TELFER – HAVIERON PROPOSAL RESPONSE TO SUBMISSIONS

Table 1 – Response to EPA Services comments

Table 2 - Response to Public Submissions

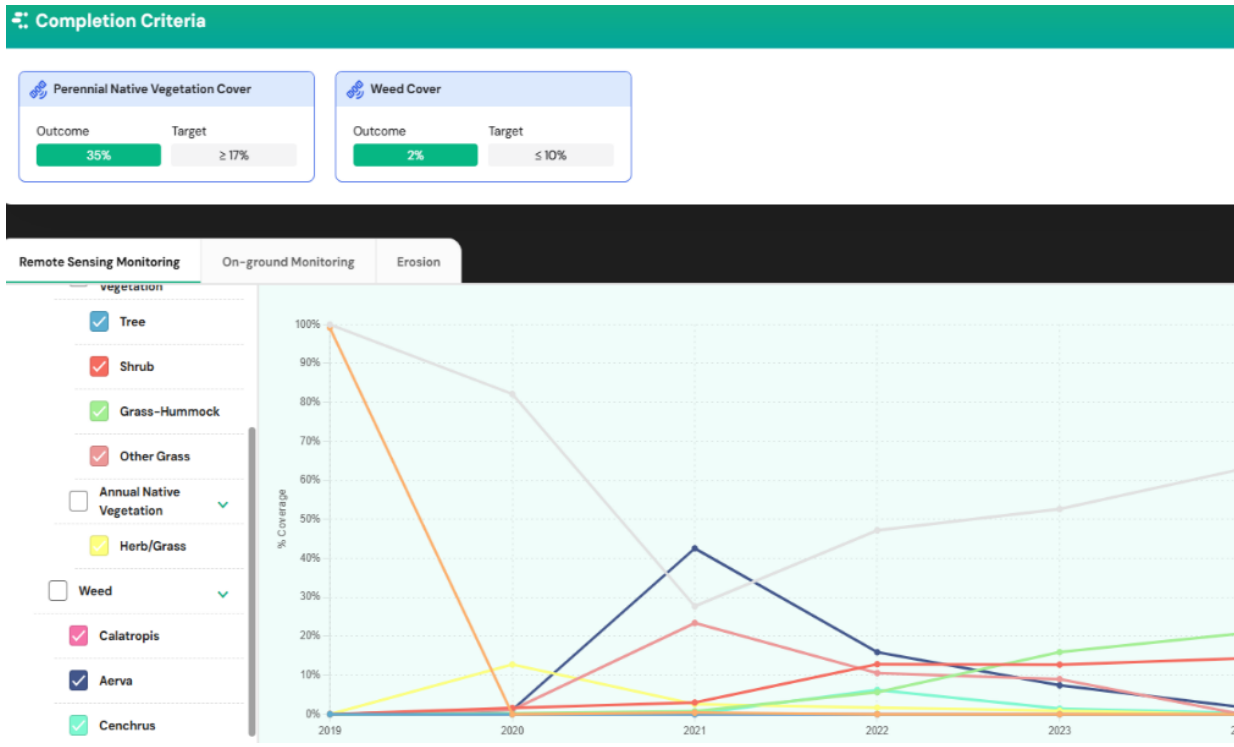
<p>Comment</p> <p>4. EPA services notes that 17 introduced flora species have been recorded in the Telfer mining area (Appendix B) while none have been recorded in the Havieron proposal and infrastructure corridor area. EPA Services advises that to prevent the spread of introduced species, there is need to review and update current management.</p>	<p>Response to Comment 4 (refer RSD, Section 5.5 and SSMPv2 Appendix J):</p> <p>Mitigations for introduced species have been revised in RSD Section 5.5 and an outcome-base mitigation proposed as Outcome 4 of the SSMP, and includes:</p> <ul style="list-style-type: none"> • annual weed survey, including remote sensing

EPA SERVICES COMMENT	PROPONENT RESPONSE
<p>Action</p> <p>Revise introduced flora species mitigation and management to include active management and monitoring practices to reduce introduced species within the approved proposal area and prevent incursion and proliferation into the expanded proposal area.</p>	<ul style="list-style-type: none"> • Standard hygiene processes including vehicle inspections (weed hygiene certificate required for outside region mobilisation of ground engaging equipment) • procedures to control vehicle and personnel movements within weed infested areas. • management of weed and native vegetation against rehabilitation criteria as outlined in the approved Mine Closure Plan. Similar criteria will be adopted for the Havieron Mine Closure Plan. <p>Successful weed control measures in place at Telfer will be extended to Havieron. An example of due diligence applied to the ongoing management of weeds in rehabilitation areas is shown below, with successful management of Kapok (dark blue line) against criteria for weeds and native vegetation cover:</p>
